ADVISORY
 BULLETIN

No. 99-11

Vapor Separator Cover (VST) – Fitting

MERCURY/MARINER
150/175/200 HP, EFI
S/N 0G826701 Thru 0G927574

a - Elbow Fitting

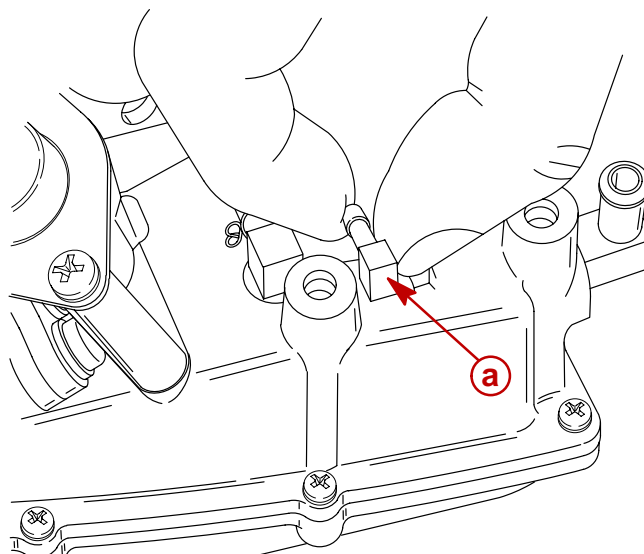
An inaccurate manufacturing process of the bleed return hose fitting on the top cover of the Vapor Separator Tank (VST) may cause the fitting to be loose. This is a pressed in elbow fitting that allows re-circulated oil/fuel from the reed block area to enter the VST. The fitting should be checked for looseness and replaced if necessary.

If the outboard is within the above serial number range and does NOT have the factory rework markings on the engine carton or engine, check the fitting for tightness. Remove the bleed return hose from the fitting, and by hand using moderate pressure try to twist the fitting in the VST cover. If the fitting can be turned by hand, it should be replaced with fitting **P/N 22 – 877324**.

If the fitting can not be turned by hand, reinstall the bleed line, and mark a WHITE dot on the side of the VST.

- a** - Elbow fitting
- b** - Serrated portion
- c** - Hammer

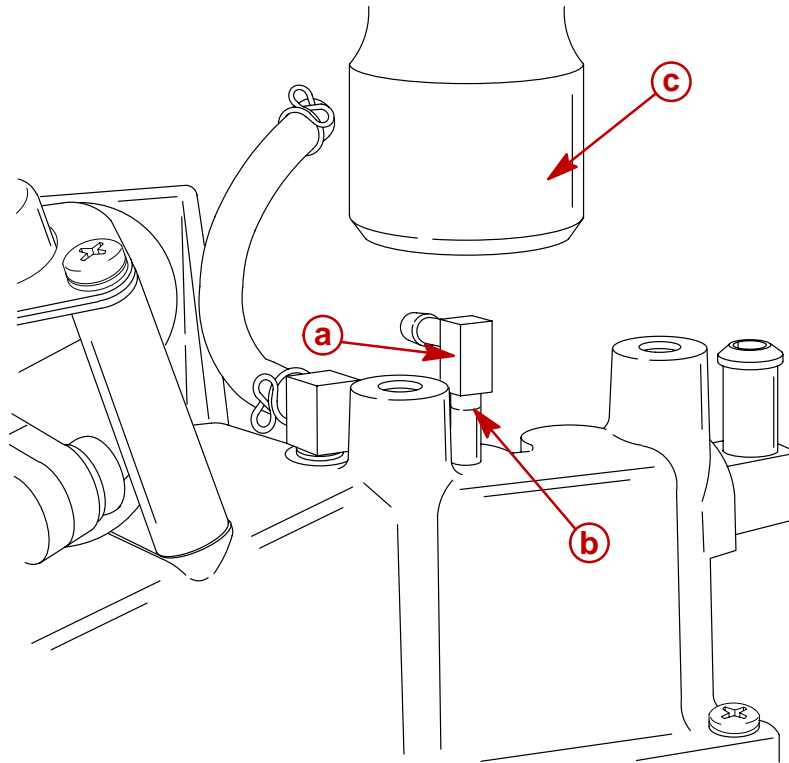
If the fitting is found to be loose, remove the old fitting. Install new fitting **P/N 22 – 877324** by carefully using a hammer to drive it into the VST cover. The fitting should be installed with the serrated portion facing down toward the cover. Check the new fitting for tightness, reinstall the bleed line, and mark a WHITE dot on the side of the VST.
